**TOWN OF MORAGA PLANNING COMMISSION  
MEETING AGENDA  
Monday, August 2, 2010  
7:30 PM**

**Subject: GRADING and HDP 01-10 Mr. and Mrs. Robert White (Owner/Applicant), 32 Buckingham Drive: Application for a hillside development permit and grading permit to grade a hillside with a slope greater than 25% including an approximately 50 cubic yard excavation for an in-ground storage building and related improvements. In accordance with Moraga Municipal Code Section 14.16.020, the Planning Commission shall make a recommendation to the Town Council regarding the proposed application. The work that is the subject of this application including the hillside excavation and partial storage room construction was commenced without the benefit of any Town approvals. The Town will evaluate the proposed application as if the work had not been started. This application will receive no special consideration because it was started without permits. The property is zoned 3 dwelling units per acre. APN: 256-203-012.**

RE: Geologic and Geotechnical Review  
Geotechnical Report and Project Plans  
Proposed Improvements to the White Property  
32 Buckingham Drive  
Moraga, California

RE: Second Geologic

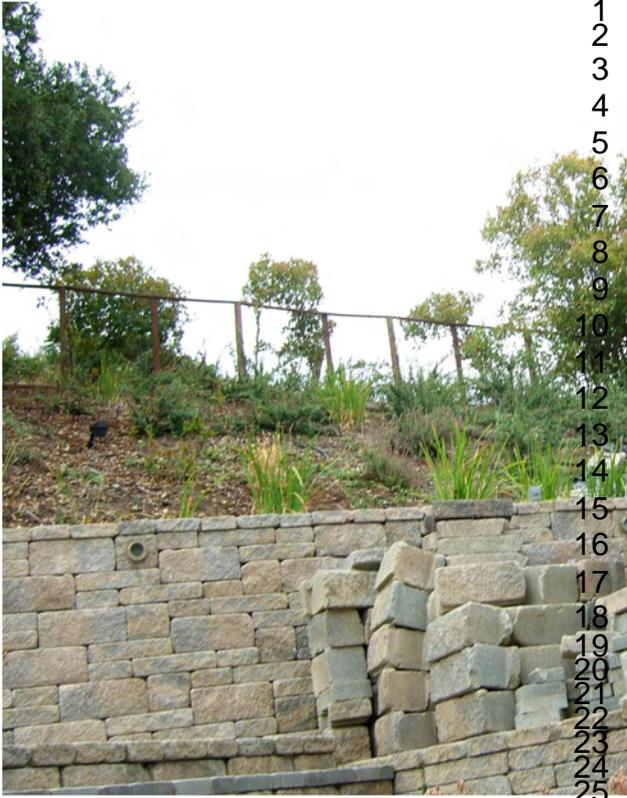
10 Photograph of the stopped construction are provided below.
